Mariposa Energy Project 09-AFC-3

RE: Golden Eagle Protection discussion with Fish and Wildlife Staff with survey exhibit.

FIGURE 1
GOLDEN EAGLE NEST SITE SURVEY
 MARIPOSA ENERGY PROJECT
 ALAMEDA COUNTY, CALIFORNIA

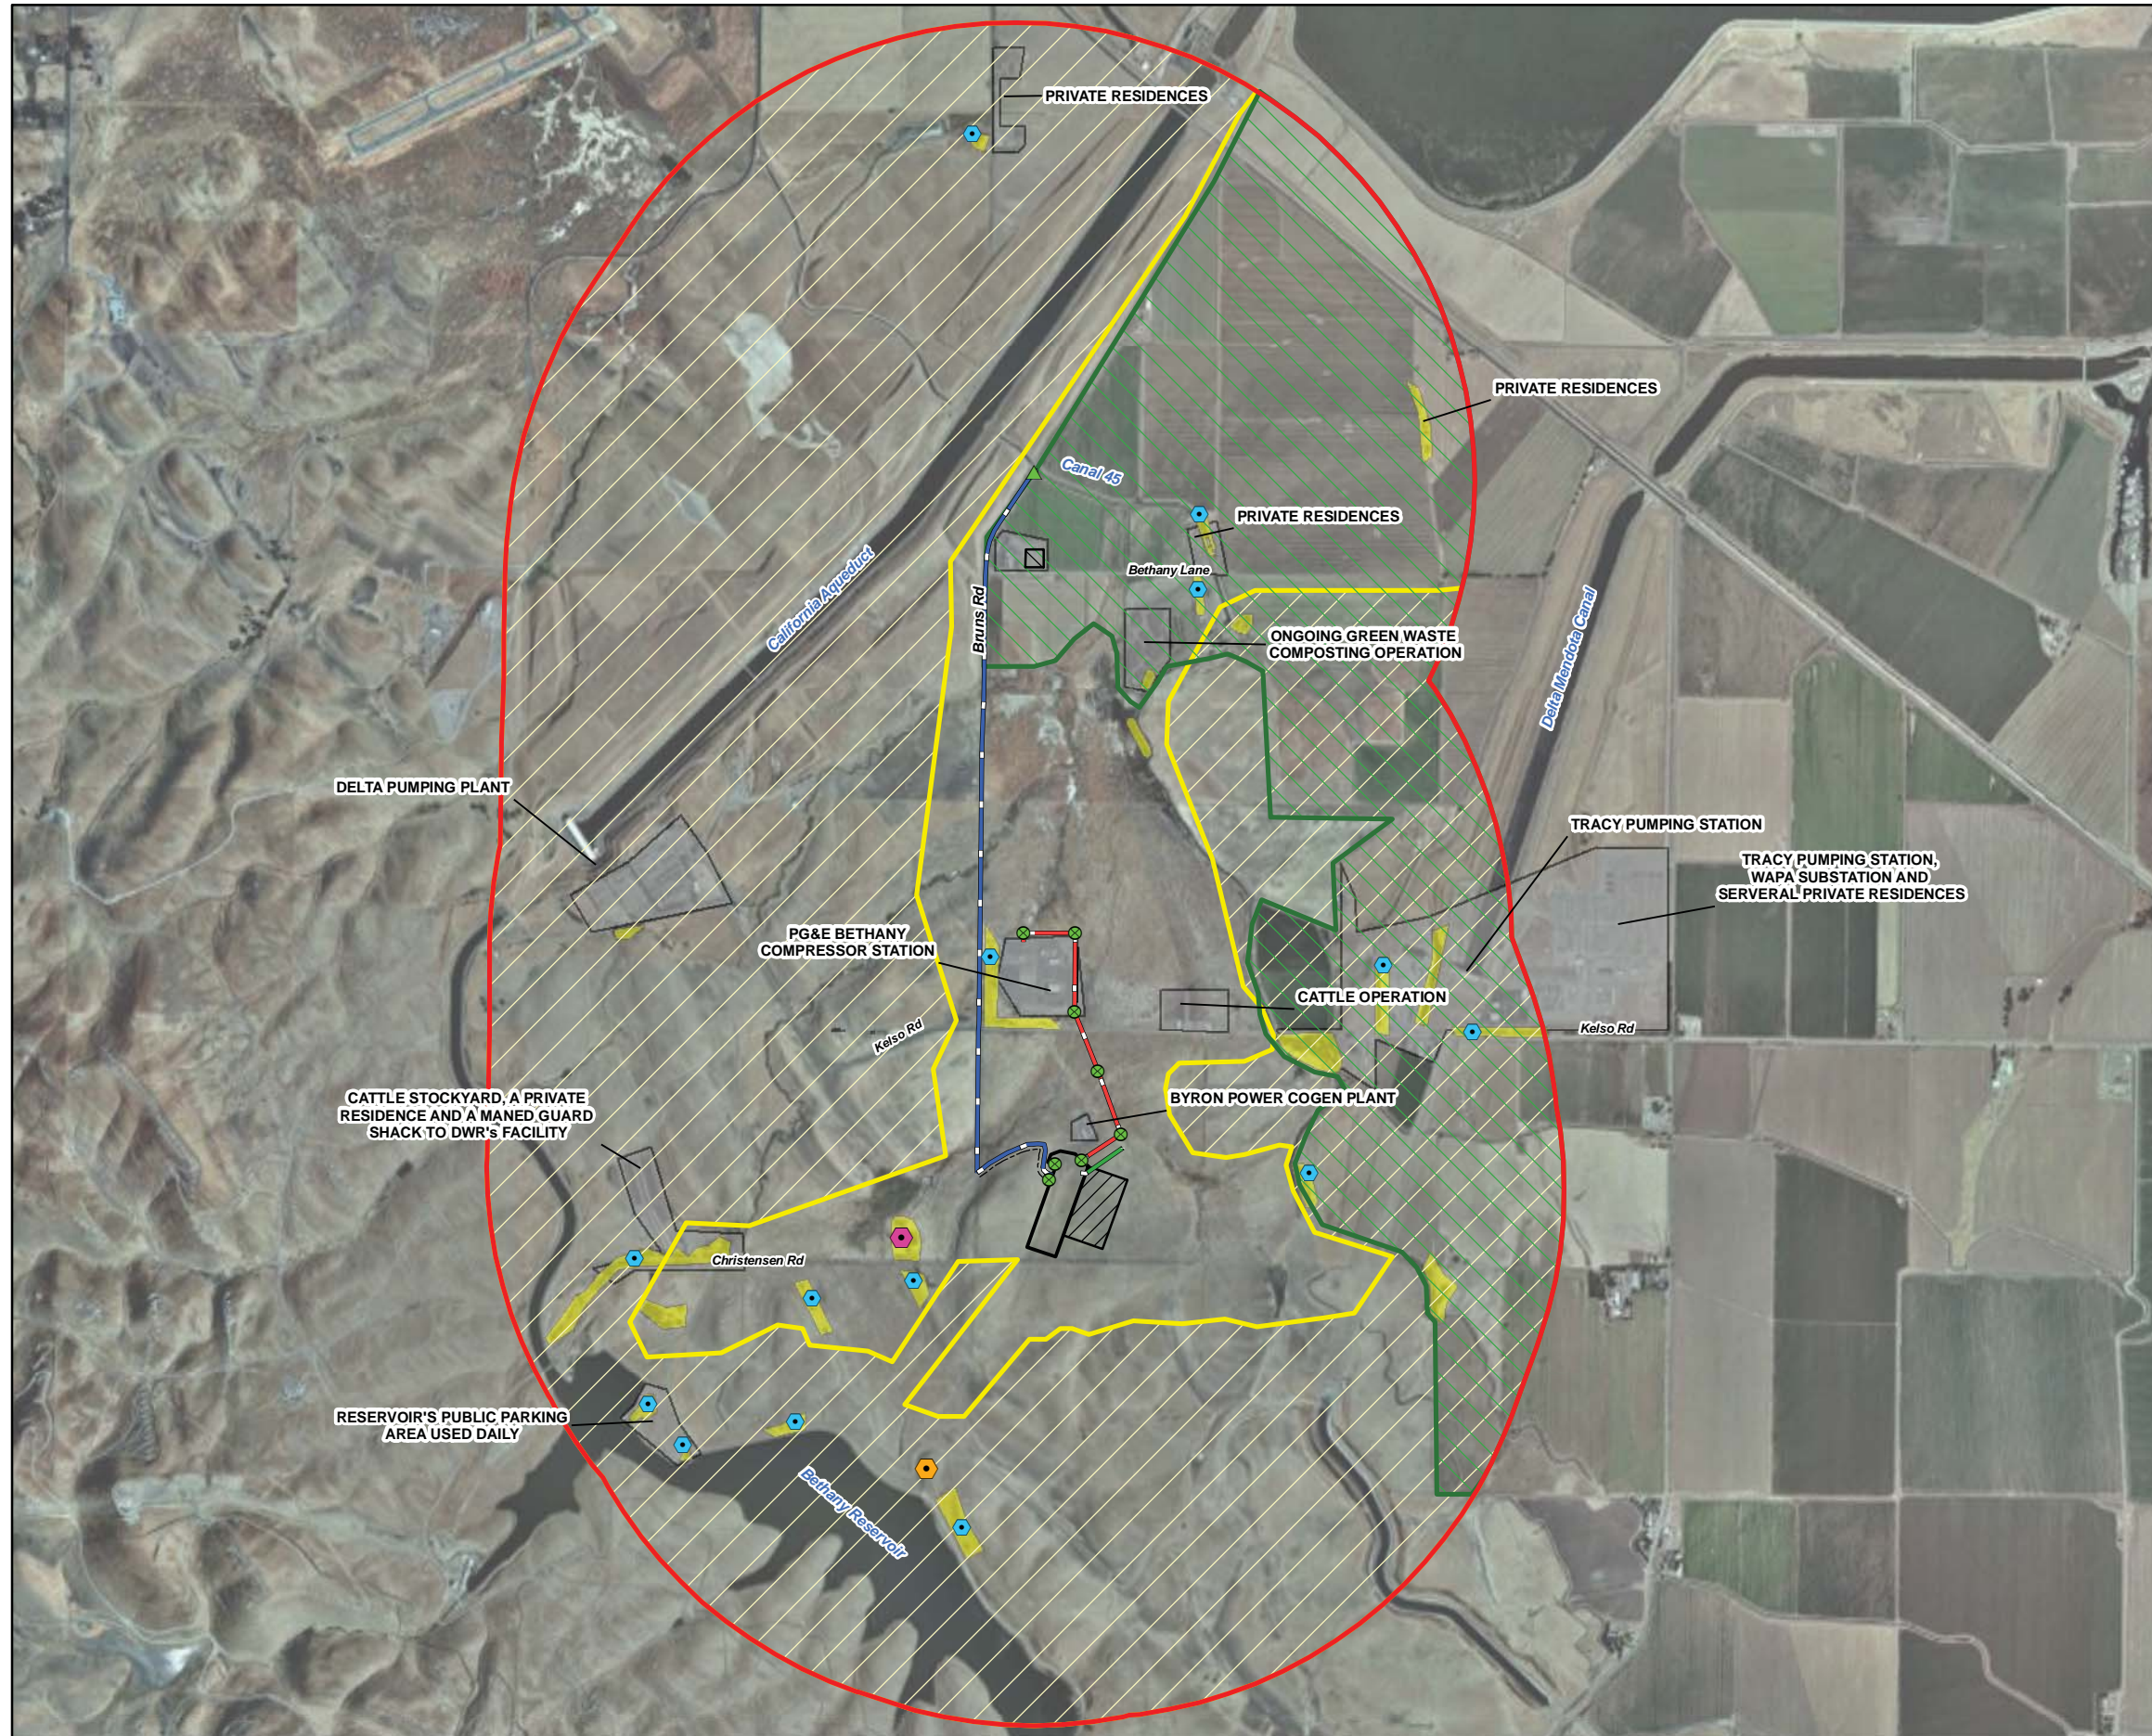
Thank you for your efforts to comply with the Bald and Golden Eagle Protection Act (16 U.S.C. 703 et seq) by surveying the project area for eagle and raptor nests. Based on the survey results, Sara Keeler's (CEC) assessment of your project and the map you provided, it appears that construction and maintenance of your project facility would not disturb or otherwise negatively impact eagles. If anything changes or new information becomes available, please contact the Service immediately.

The Service has conservation responsibilities and management authority for migratory birds under the Migratory Bird Treaty Act (MBTA) of 1918, as amended (16 U.S.C. 703 et seq.). The proposed project should be evaluated for potential impacts to migratory birds in the area. Under the MBTA, nests (nests with eggs or young) of migratory birds may not be harmed, nor may migratory birds be killed. Such destruction may be in violation of the MBTA. Therefore, land clearing, or other surface disturbance associated with proposed projects, must be conducted outside the avian breeding season to avoid potential destruction of bird nests or young, or birds that breed in the area. If this is not feasible, a qualified biologist should conduct a survey of the area prior to land clearing. If nests are located, or if other evidence of nesting (i.e., mated pairs, territorial defense, carrying nesting material, transporting food) is observed, a protective buffer (the size depending on the habitat requirements of the species) should be delineated and the area avoided to prevent destruction or disturbance to nests until they are no longer active.
